Subject: Revision 1 to Transnuclear, Inc. (TN) Application for Amendment 11 to the Standardized NUHOMS® System (Docket No. 72-1004; TAC NO. L24080)

References:
1. Letter from Joseph M. Sebrosky (NRC) to Donis Shaw (TN), "REQUEST FOR ADDITIONAL INFORMATION FOR REVIEW OF AMENDMENT 11 TO THE STANDARDIZED NUHOMS® SYSTEM (TAC NO. L24080)," October 22, 2007
2. Letter from Robert Grubb (TN) to Document Control Desk, "Supplemental Information Regarding the Application for Amendment 11 of the NUHOMS® Certificate of Compliance No. 1004 for Spent Fuel Storage Casks, Revision 0, Docket No. 72-1004, (TAC No. L24080)", August 23, 2007

This submittal provides responses to the request for additional information (RAI) forwarded by Reference 1. Enclosure 2 herein provides each of the NRC staff RAI followed by a TN response. Enclosure 3 provides and updated cross reference list between proposed Amendment 10 and proposed Amendment 11 Technical Specifications. Enclosure 4 provides Amendment 11 Revision 1 proposed changes to the NUHOMS® CoC 1004 (Amendment 9), the associated Technical Specifications, and the Standardized NUHOMS® System UFSAR (Revision 9). Enclosure 5 provides updated sheets listing th

Figure 1-1
PWR Fuel Criticality Acceptance Curve

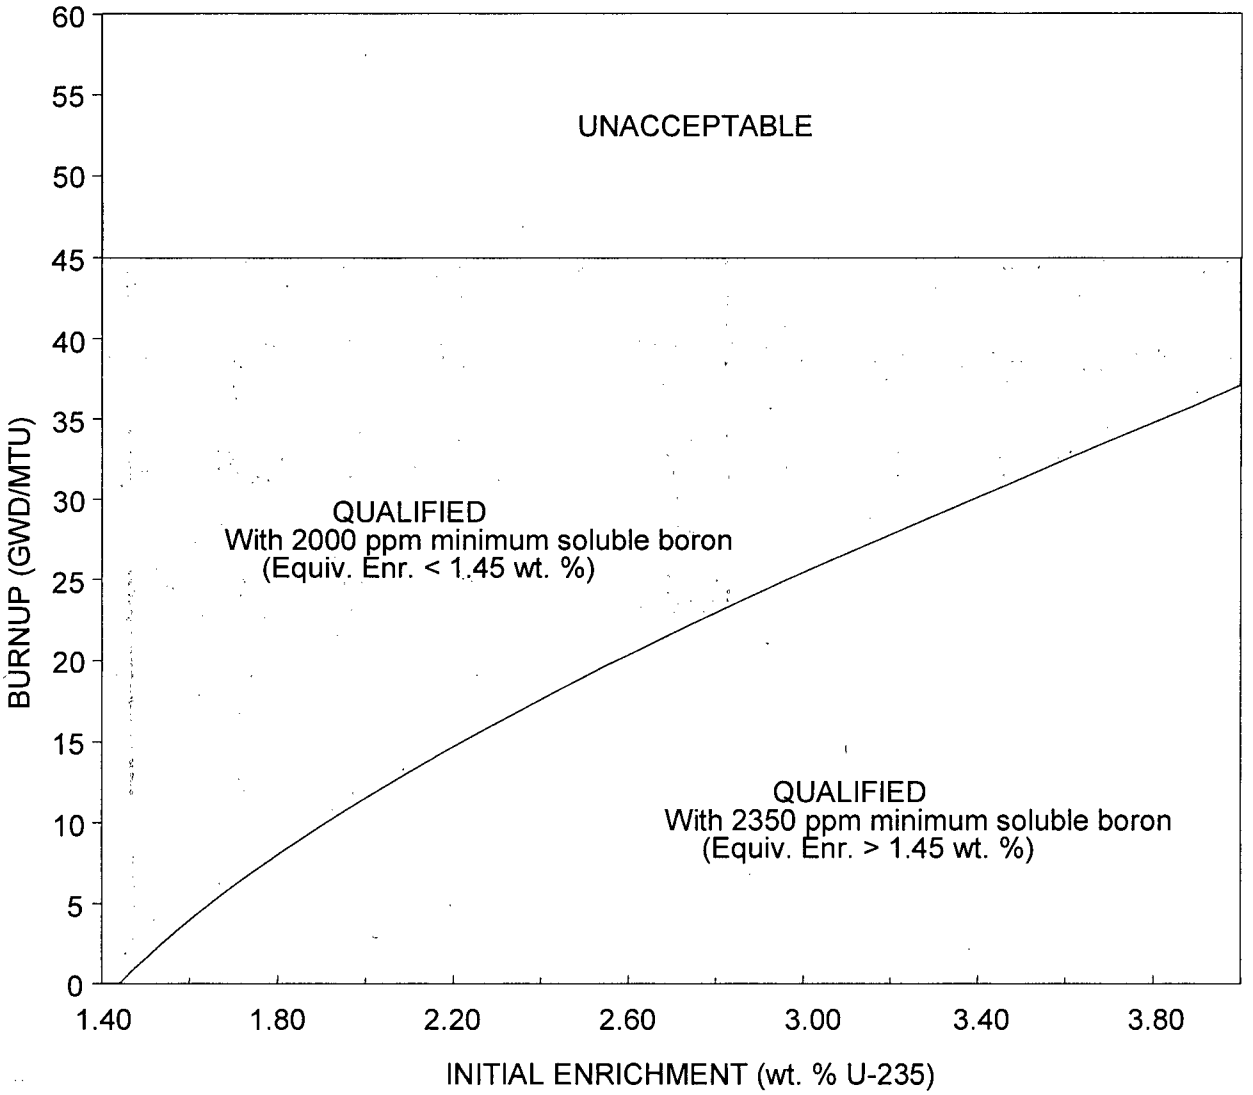
On Page T-2 under specifications for burnup, it refers to Figure 1.1. There is no such figure. The staff believes the correct reference should be to Table 1-2b.

There is no need to reference any figure or table. The reference to "Figure 1.1" is deleted in Technical Specifications Table 1-1b. The corresponding table in the UFSAR (Table 3.1-2) is also changed to match.

Figure W.5-1
OS197L TC *MCNP Shielding Configuration Description*

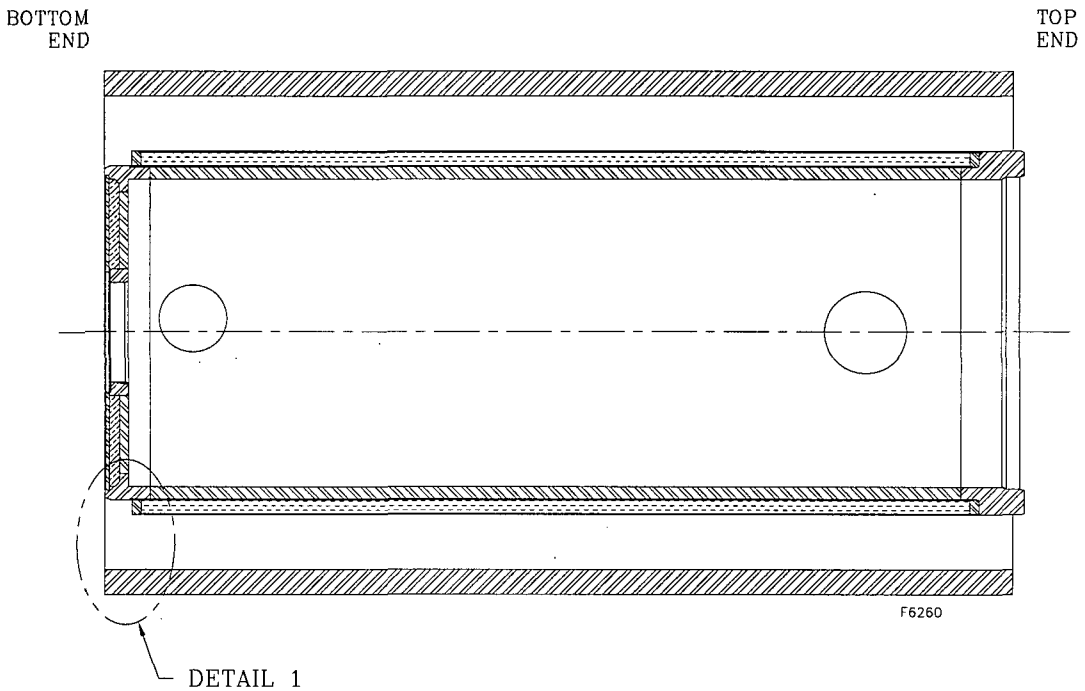
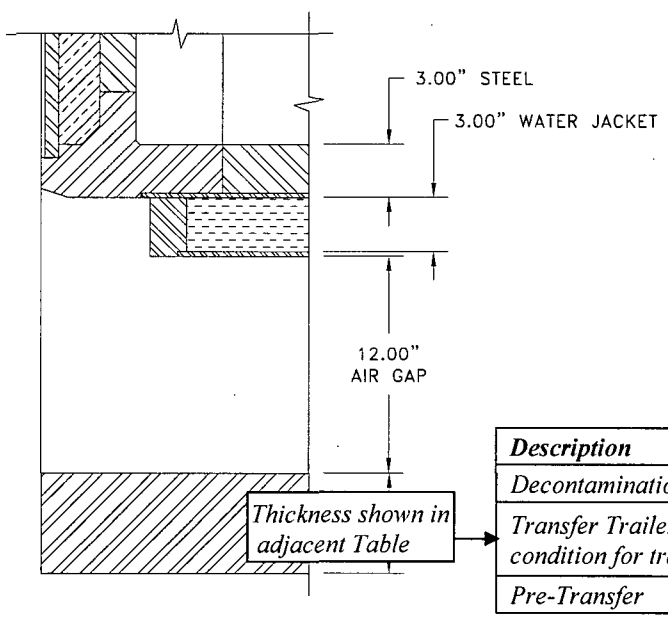
b. Revise Figure W.5-1 to provide a level of detail similar to Figure M.5-24, showing all axial and radial dimensions modeled in the 3-D MCNP analysis.

5-39 Clarify the apparent discrepancy between Figure W.5-1 and Figure W.1-2.

Figure W.5-1 shows that the decontamination area shielding was modeled as 5.5-inches of steel. However, Figure W.1-2 indicates that the decontamination area supplemental shielding is 6-inches thick. Clarify this apparent discrepancy.

See response to 5-38 above. Figure W.5-1 describes the configuration as modeled.
